**Subject: Comments on the Upper Ventura River Groundwater Agency Draft Groundwater Sustainability Plan**

The California Department of Fish and Wildlife (CDFW) appreciates the opportunity to provide comments on the Upper Ventura River Groundwater Agency's (UVRGA) Draft Groundwater Sustainability Plan (Draft GSP) prepared pursuant to the Sustainable Groundwater Management Act (SGMA).

Figure 2.3. Surface Water Bodies – Hydrologic Conditions.

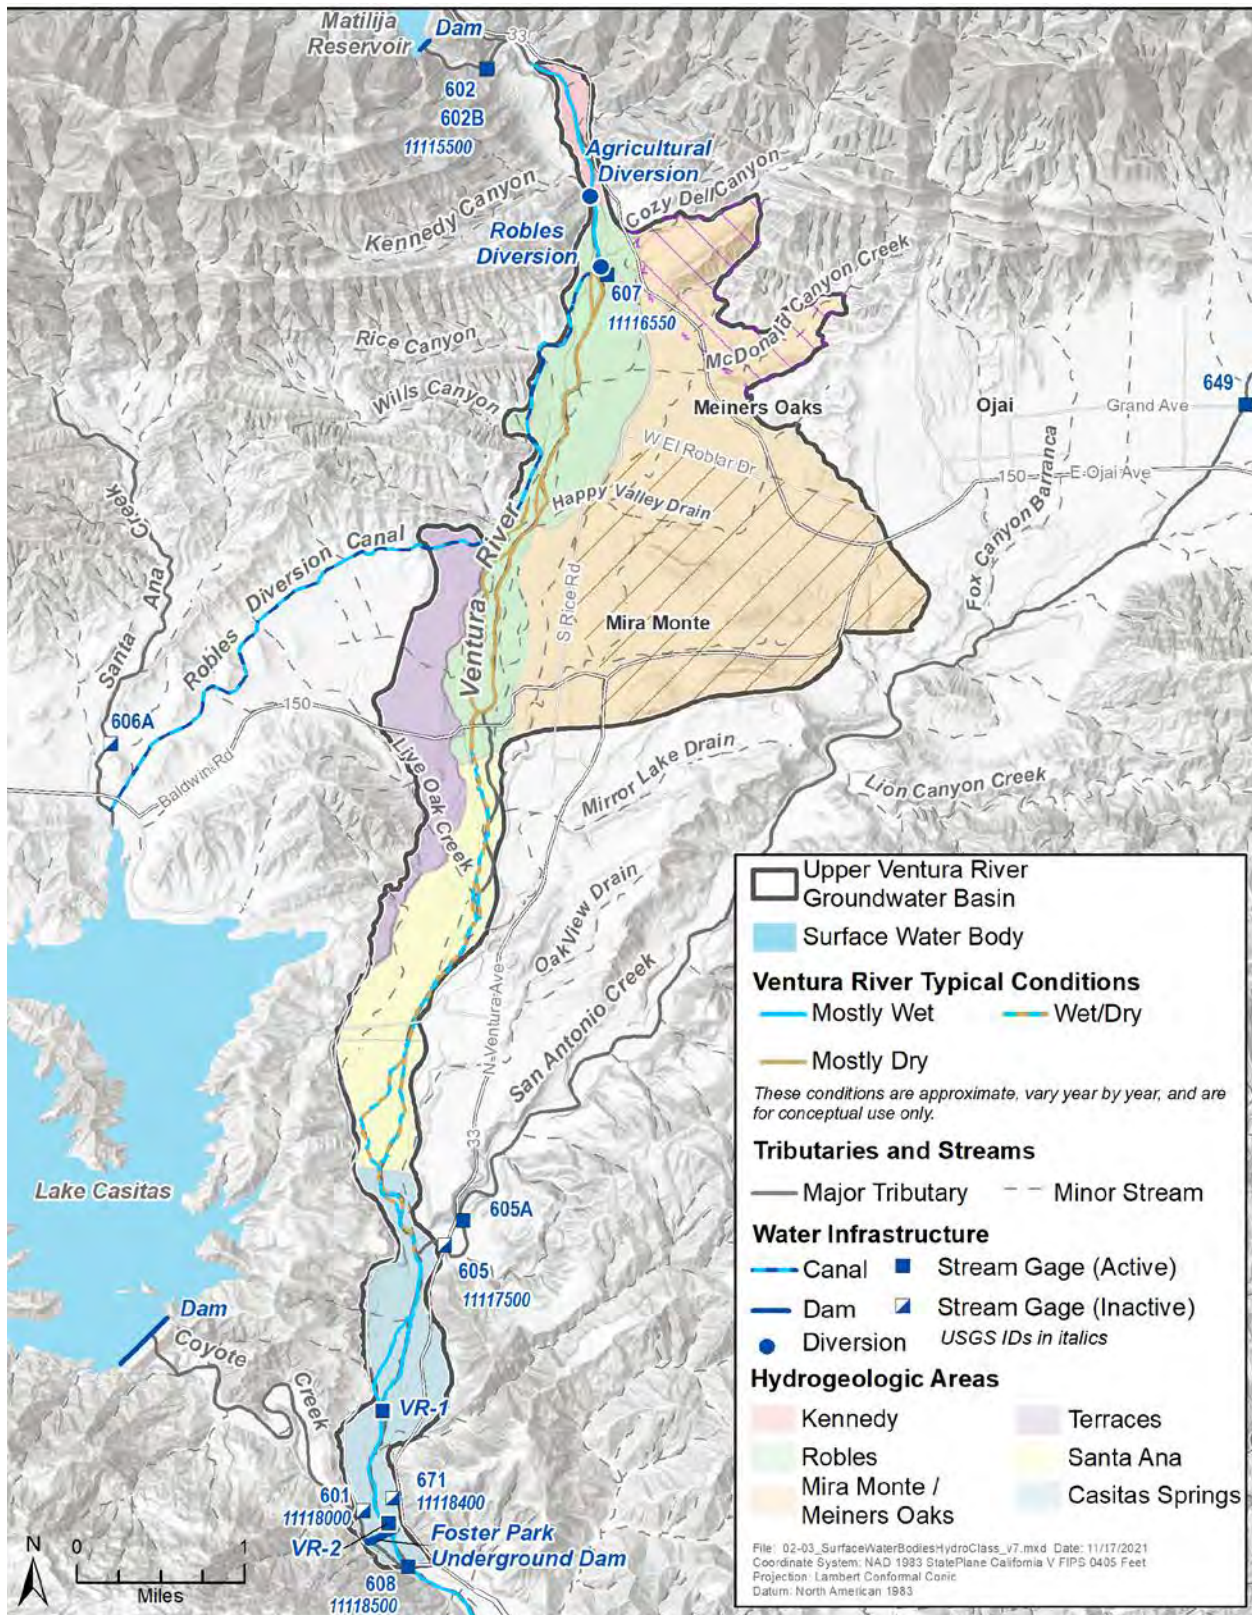
Figure 3.2-11 (Surface Water Bodies – Hydrologic Conditions) labels sections of the Ventura River as: (1) Losing Reach with Intermittent Groundwater- Surface Water Interconnection, (2) Losing Reach with Generally Disconnected Groundwater- Surface Water, (3) Variably Losing or Gaining Reach with Intermittent Groundwater- Surface Water Interconnection, and (4) Gaining Reach with Generally Interconnected Groundwater - Surface Water. We recommend that these labels are clarified in the text so it is more clear which stream segments are retained as ISWs or potential ISWs in the GSP.

- Describe the legend labels used on Figure 3.2-11 in the GSP text to make clear which stream segments are retained as ISWs or potential ISWs in the GSP.

- Overlay the stream reaches shown on Figure 3.2-11 with depth-to-groundwater contour maps to illustrate groundwater depths and the groundwater gradient near the stream reaches. Show the location of groundwater wells used in the analysis.

- Describe data gaps for the ISW analysis in the ISW section, in addition to the discussion in Sections 3.1.4 (Data Gaps and Uncertainty). On Figure 3.2-11, include reaches with data gaps as potential ISWs.
